UNITED STATES PATENT AND TRADEMARK OFFICE

Office Action Summary	Application No. 10/614,729	Applicant(s) DARBY ET AL.	
	Examiner Saúl J. Rodríguez	Art Unit 3681

DETAILED ACTION

This is a first office action on the merits of patent application S. N. 10/614,729.

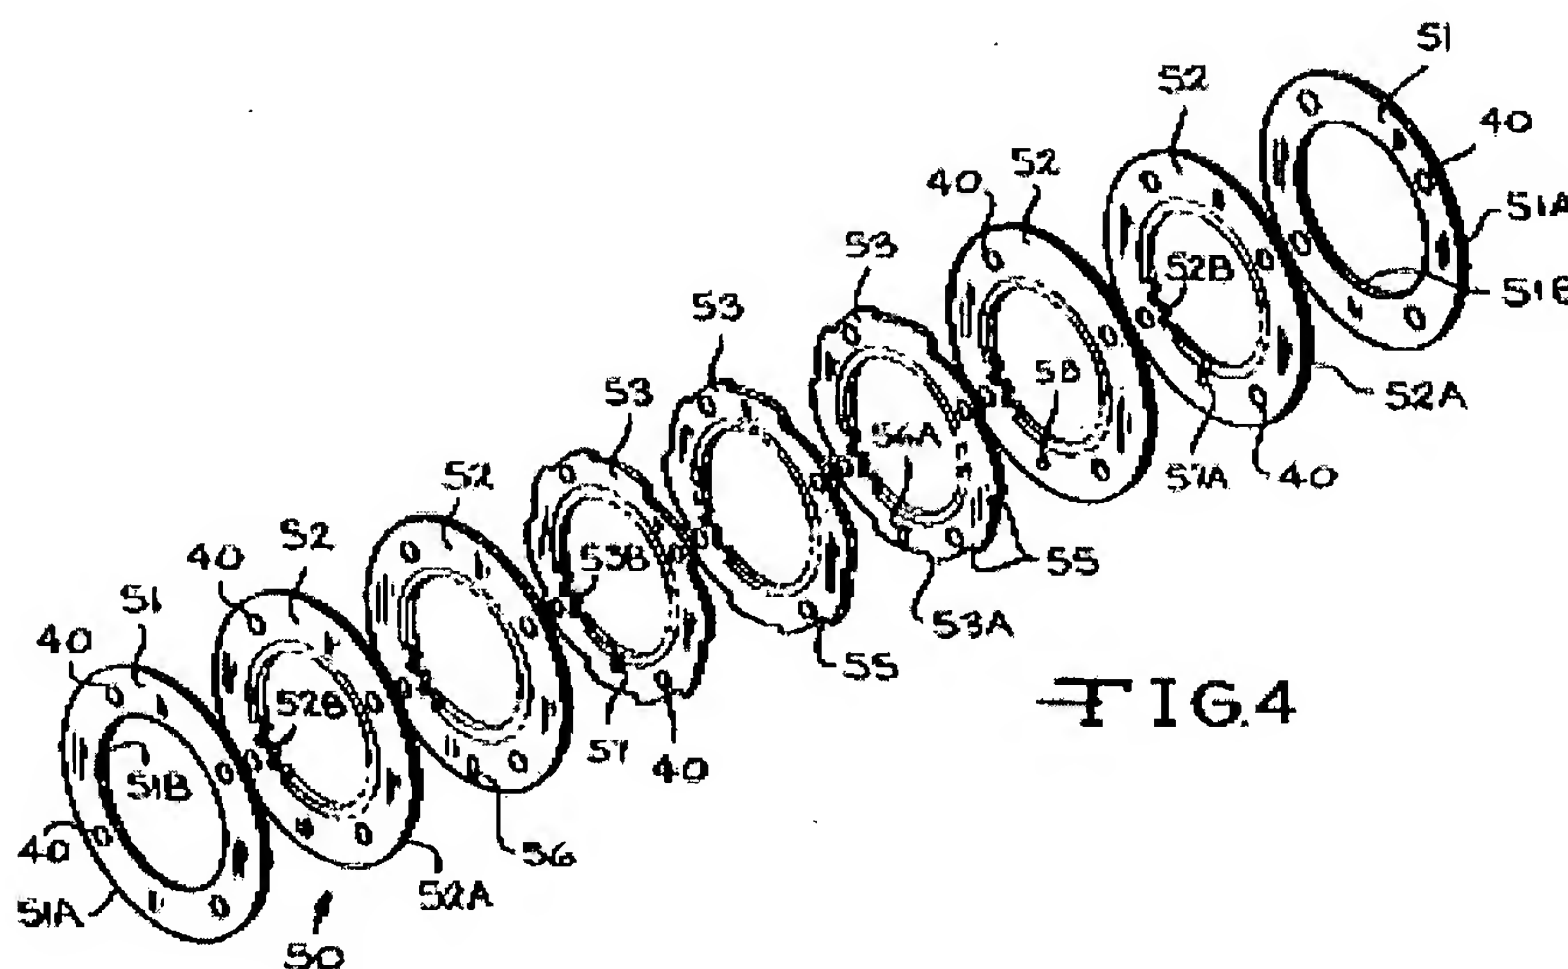
Claims 1-6 and 8, as understood, are rejected under 35 U.S.C. 102(b) as being anticipated by Quigley ('279).

Quigley discloses a no-back device (Fig. 1) comprising a plurality of ratchet members (22) connectable to a rotating member, pawls (25), interlocking means (40), projections and indentations (Fig. 3, 40, 41). Regarding the limitation that the "ratchets/pawls members are formed from respective materials having different chemical and/or physical properties", the prior art discloses discrete members that would inherently exhibit distinct properties (point, linear, planar, and three-dimensional defects; in additions to those unique qualities caused by processing – e.g., voids, etc.) that yielding different physical traits. Concerning claim 1, since no frame of reference has been given for the angular offset of the ratchet member (e.g., teeth), any two arbitrary points would satisfy the claimed limitation.
